ER-RI-5
03/04/90
NJDEP COMMENTS ON RI PROG

Re: IRP Phase III RI/FS Work Plan
Quality Assurance Project Plan
Health and Safety Plan

NEW JERSEY DEPARTMENT OF ENVIRONMENTAL PROTECTION
 MONITOR WELL SPECIFICATIONS FOR
 CONFINED UNCONSOLIDATED AQUIFERS

Attachment 1

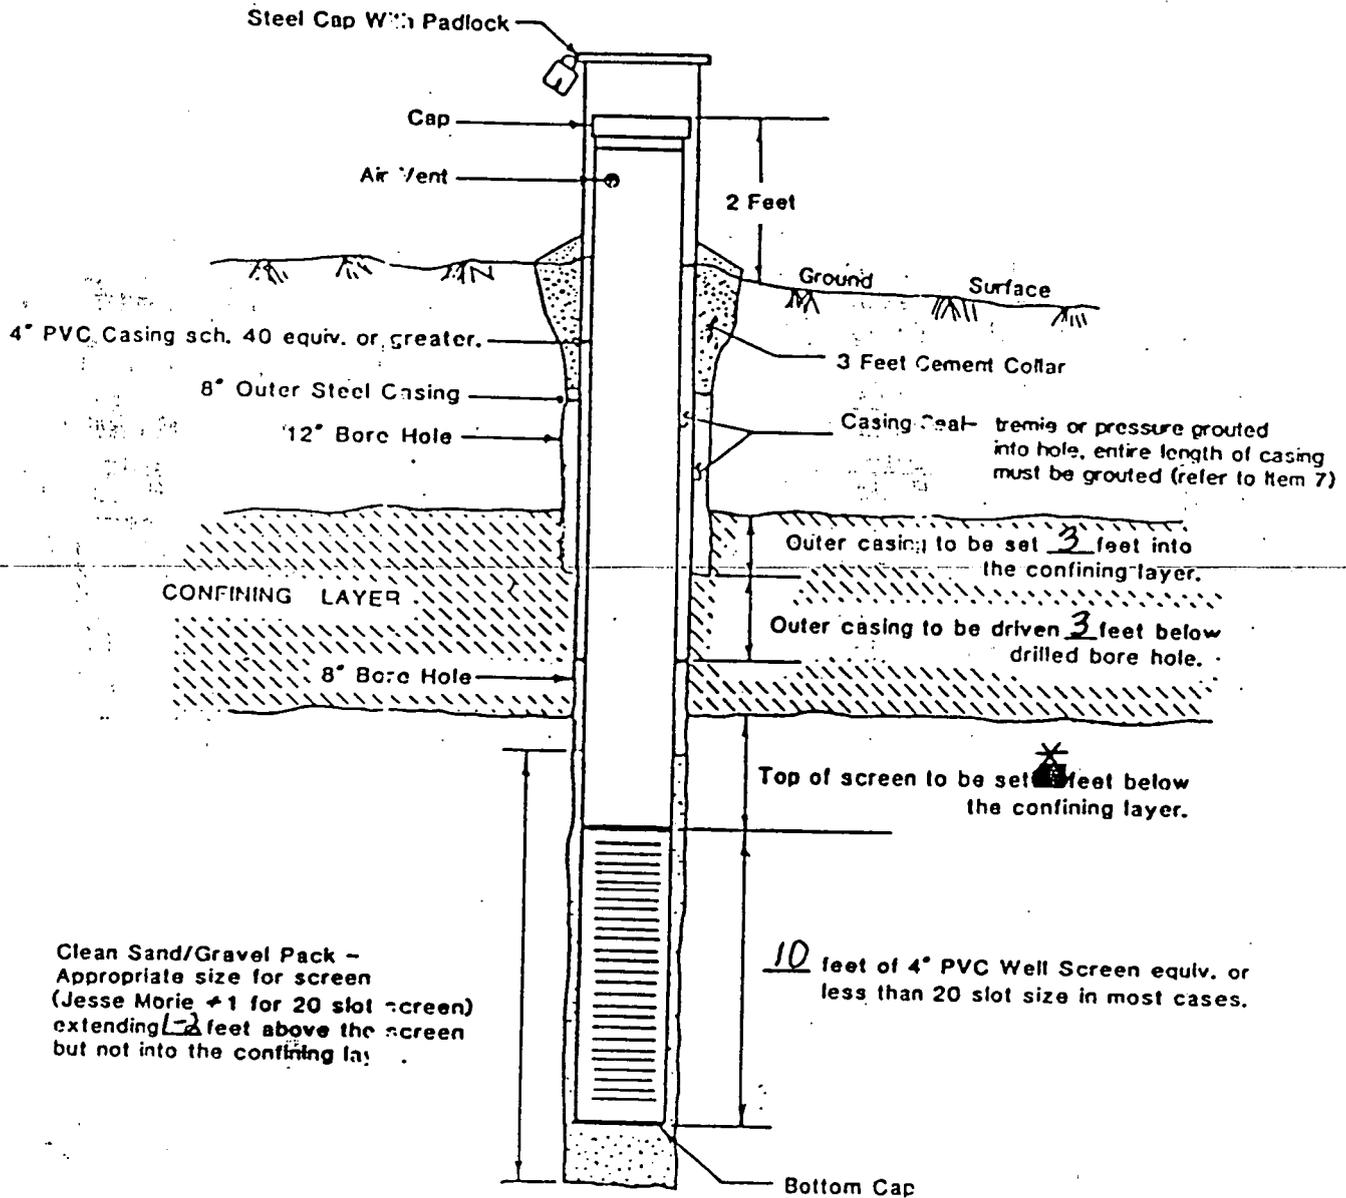
A double-cased monitor well construction diagram must be included in this section of the subject document. This diagram is needed since the deep monitor well to be installed into the Englishtown Aquifer must be double cased to prevent contamination migration via the borehole (see Attachment 1).

1. Notification to the NJDEP is required two (2) weeks prior to drilling.
2. State well permits are required for each monitor well constructed by the driller. Report "use of well" on permit application as ground water monitoring. Permit number must be permanently affixed to each monitoring well. NOTE: Well driller must be licensed in the State of New Jersey.

3. All boreholes must be a minimum of four (4) inches greater in diameter than the immediate casing it surrounds.
4. Wells must be gravel packed unless noted otherwise in the Additional Requirements and under no circumstance is the gravel pack to penetrate a confining layer.

5. Casing sealant, drilling fluids and cement must be mixed with potable water.
6. The borehole for the out steel casing is to be drilled and the casing driven, grouted and allowed to set prior to drilling through any confining layer.

8. The grout for the inner PVC cased well must extend to the ground surface.
9. The cement collar should be installed one (1) hour after the inner casing seal has been emplaced and not while the outer casing seal is setting.
